WALSH BAY ARTS AND CULTURAL PRECINCT

SSDA 8671

ACCESS REPORT

22nd September 2017

Sydney Philharmonia Choirs

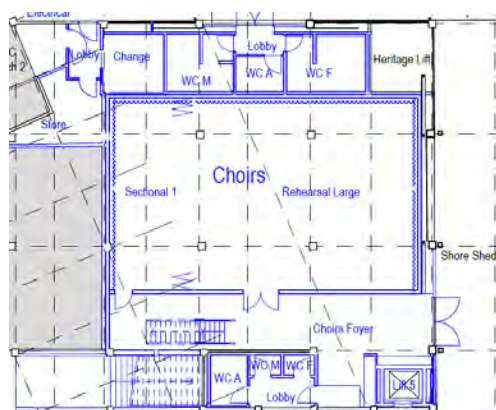
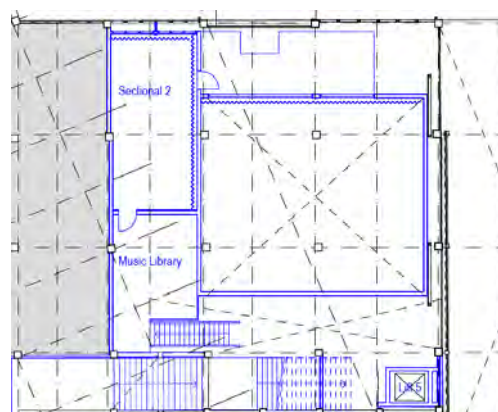
105. **Choirs** – The foyer entrance provides ample door circulation space to approach the entry doorways while the active door leaf shall be upgraded to 920mm minimum to achieve 850mm minimum clear opening width, door hardware and threshold ramp detailing to comply with AS1428.1 to satisfy D3.2 of the BCA and DDA Premises Standards.

106. The internal foyer area and access corridors throughout the ground floor provide doorway circulation spaces, Turning and Passing Areas in appropriate locations that comply with AS1428.1 to satisfy D3.3 of the BCA to approach, enter and exit the rehearsal room and sanitary facilities.

BCA / DDA Access Code Review	Compliance
<p>107. Sanitary facilities – The foyer sanitary facilities include male and female ambulant sanitary facilities and a unisex wheelchair accessible toilet that will comply with ASI428.1 and F2.4 of the BCA.</p> <p>108. Mezzanine Floor Access – The plans propose stairway access as the only means to access the mezzanine level and no lift, which does not comply with the deemed to satisfy requirements of Part D3 of the BCA. However, there are options for a performance based solutions to satisfy the performance requirements of DPI of the BCA, including the future installation of a stairway platform lift on the 1500mm width stairway currently shown on the plans.</p> <p>109. Stairways – The plans show an internal stairway to the mezzanine level which requires handrails on both sides with extensions at landings and other features as specified by ASI428.1 and ASI428.4.1 to satisfy D3.3, D2.14 and D3.8 of the BCA.</p>	<p>YES</p> <p>Can Comply</p> <p>YES at CC stage</p>

Commercial Tenancy 2

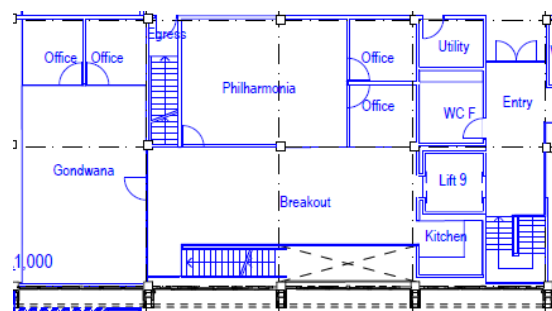
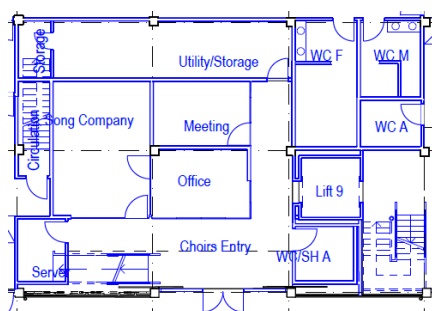
112. Shore Shed 5 contains a commercial no. 2 tenancy and bike store, which requires either an external ramp to eliminate the two steps or the internal floor area lowered approximately 300mm to comply with ASI428.1 and satisfy D3.2 of the BCA. Detailed design shall confirm doorway access to and within the tenancy while the open plan room access complies with ASI428.1.

BCA / DDA Access Code Review	Compliance
<p>I 13. The Waste Room and Precinct Store are areas exempted by clause D3.4 of the BCA and DDA Access Code due to the use and potential health hazard to people with disabilities.</p>	YES
<p>Visitor Portal and Office</p> <p>I 14. The plans illustrate a Visitor Portal and Office adjacent to the entrance breezeway that proposes a double doorway with ample circulation spaces and general level landing and threshold that will comply with ASI428.1 and satisfy part D3.2 of the BCA and DDA Access Code.</p> <p>I 15. The open plan internal area has no inherent access barriers and will also comply with ASI428.1 and satisfy part D3.3 of the BCA and DDA Access Code.</p>	<p>YES</p> <p>YES</p>

Commercial Tenancies 3 & 4

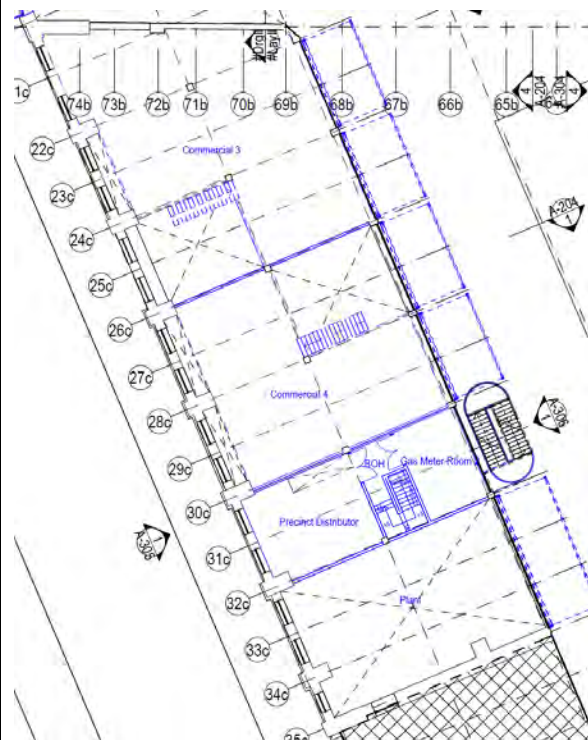
- I 16. Commercial tenancy plans shall be detailed at the construction documentation phase to include external ramps and raised doorway landings to eliminate the step thresholds and 920mm minimum entrance doors, lever door handles, doorway luminance contrast complying with ASI428.1 to satisfy D3.2 of the BCA and DDA Premises Standards.
- I 17. The open plan internal layout of the tenancy is across a single ground floor level and will comply with ASI428.1 to satisfy D3.3 of the BCA.

BCA / DDA Access Code Review	Compliance
<p>118. Mezzanine Floor Access – The plans propose stairway access to a mezzanine level of approximately 80 sqm for each tenancy and no lift.</p> <p>119. The mezzanine areas are generally small scale nature and depending on the future use of the areas the occupants may require a performance based solution to satisfy the performance requirements of DPI of the BCA, or a future installation of a stairway platform lift on a 1500mm width stairway.</p> <p>120. Regardless of the use the stairways will require detailing at the construction certificate stage to include handrails on both sides with extensions at landings and other features as specified by AS1428.1 and AS1428.4.1 to satisfy D3.3, D2.14 and D3.8 of the BCA including barriers around the stairway undercrofts where the headroom is less than 2000mm.</p>	<p>YES at CC stage</p>
<p>Common Area Public Toilets</p> <p>121. Common Area Public Toilets – The plans propose a group of toilets that include a unisex wheelchair accessible toilet, male and female ambulant accessible toilet in accordance with AS1428.1 to satisfy F2.4 of the BCA, subject to the internal airlock providing 1450mm minimum depth internally.</p>	<p>YES Can comply</p>

Sydney Dance Company (SDC)

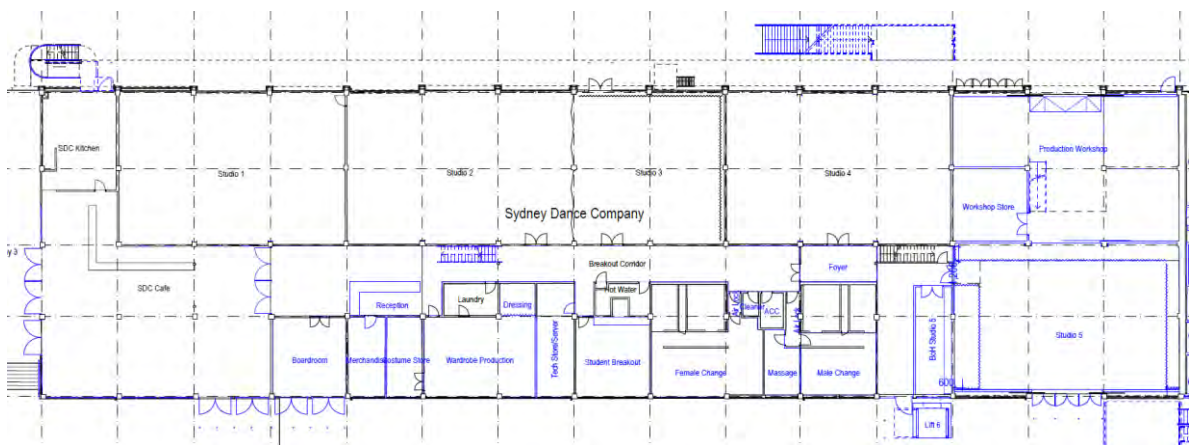
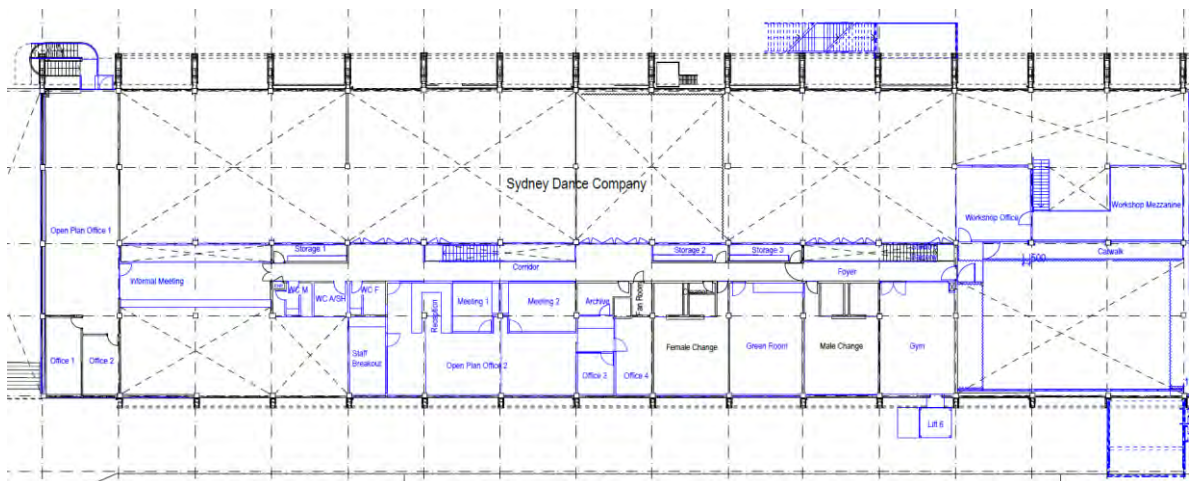
127. **Ground Floor** - The plans propose the existing internal café stair will be removed and a new double doorway entrance to the SDC reception areas which provides appropriate circulation spaces to comply with

BCA / DDA Access Code Review	Compliance
<p>ASI428.1 and D3.3 of the BCA. Studio 5 indicates an external doorway and the adjacent foyer show an external door which must be detailed to comply with ASI428.1 including circulation spaces.</p> <p>128. The new Merchandise room and reduced Costume Store can provide appropriate access subject to the entry door into the Wardrobe Production being re-installed as a 920mm door with 530mm latchside clearance.</p> <p>129. The new partitions and doorways adjoining Studio 5 and the Workshop provide appropriate access and circulation spaces to comply with ASI428.1 and D3.3 of the BCA.</p>	<p>Can Comply</p> <p>YES can comply</p> <p>YES</p>

130. The ground floor plans indicate refurbished sanitary facilities which include a unisex wheelchair accessible toilet and while the size may not comply with ASI428.1 (2009) section 4.5 of the DDA Premises Standards provides a concession for facilities constructed prior to 2011 to remain the size of ASI428.1 (2001) and simply upgrade the fixtures to comply with ASI428.1 (2009).

BCA / DDA Access Code Review	Compliance
<p>131. Stairways – The plans show several stairways to access the mezzanine level which require handrails on both sides with extensions at landings and other features as specified by AS1428.1 and AS1428.4.1 to satisfy D3.3, D2.14 and D3.8 of the BCA including barriers around the stairway undercrofts where the headroom is less than 2000mm.</p> <p>132. Lift Access – The existing platform hoist (lift 10 on the demolition plan) will be replaced by a passenger lift no 6.</p> <p>133. Mezzanine Level - The mezzanine floor plan illustrates reconfigured Office accommodation, new sanitary facilities, Studio 5 balcony, adjacent Workshop offices and several storage areas.</p> <p>134. The access paths to and within these areas will comply with AS1428.1 subject to the Studio catwalk balcony being increased to 1600mm to achieve 530mm latchside clearance.</p> <p>135. The plans propose a group new toilets that includes a unisex wheelchair accessible toilet and shower, male and female ambulant accessible toilet in accordance with AS1428.1 to satisfy F2.4 of the BCA,</p>	<p>YES Will Comply</p> <p>YES</p> <p>YES Can Comply</p> <p>YES</p>

Ground Floor Plan

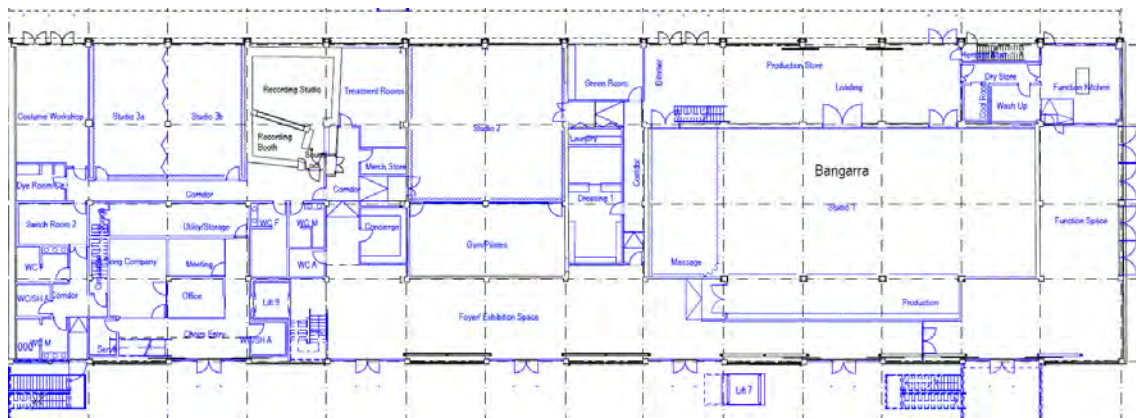
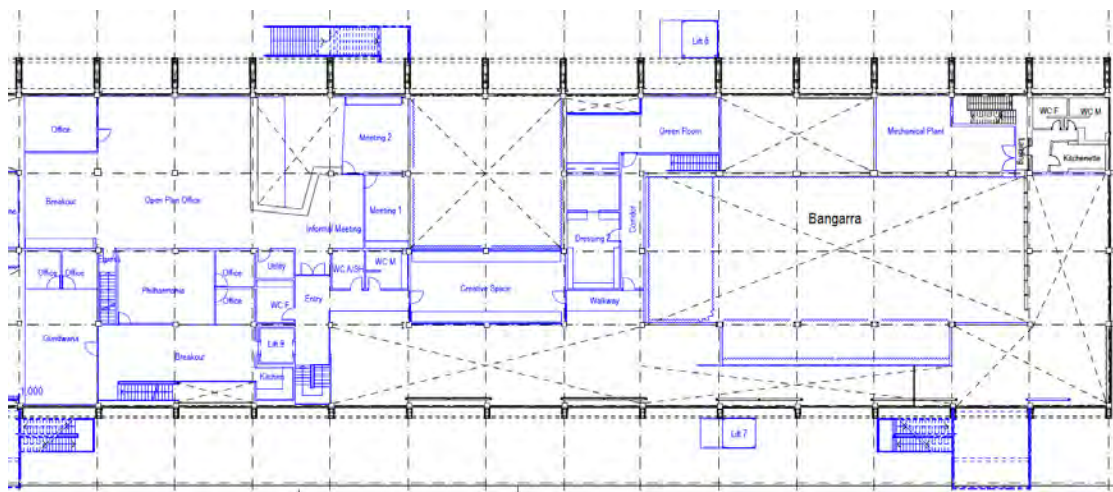
140. **Lifts** – The design shows a new lift No. 9 located centrally in the main foyer area that will travel to the mezzanine level and provide a significant lift car of at least 2000mm X 1800mm to accommodate two people using wheelchairs and facilitate high volume passenger movements.

141. **Mezzanine Level** - The corridor accessways throughout the mezzanine level propose 1600mm–2000mm width to approach doorways to enter rooms in accordance with AS1428.1 to satisfy D3.3 of the BCA.

142. **Sanitary facilities** – There are sanitary facilities on both levels which include a unisex wheelchair accessible toilet and ambulant accessible male and female cubicles that comply with AS1428.1 to satisfy F2.4 of the BCA.

143. **Stairways** – The plans show several stairways to access the mezzanine level which require handrails on both sides with extensions at landings and other features as specified by AS1428.1 and AS1428.4.1 to satisfy D3.3, D2.14 and D3.8 of the BCA.
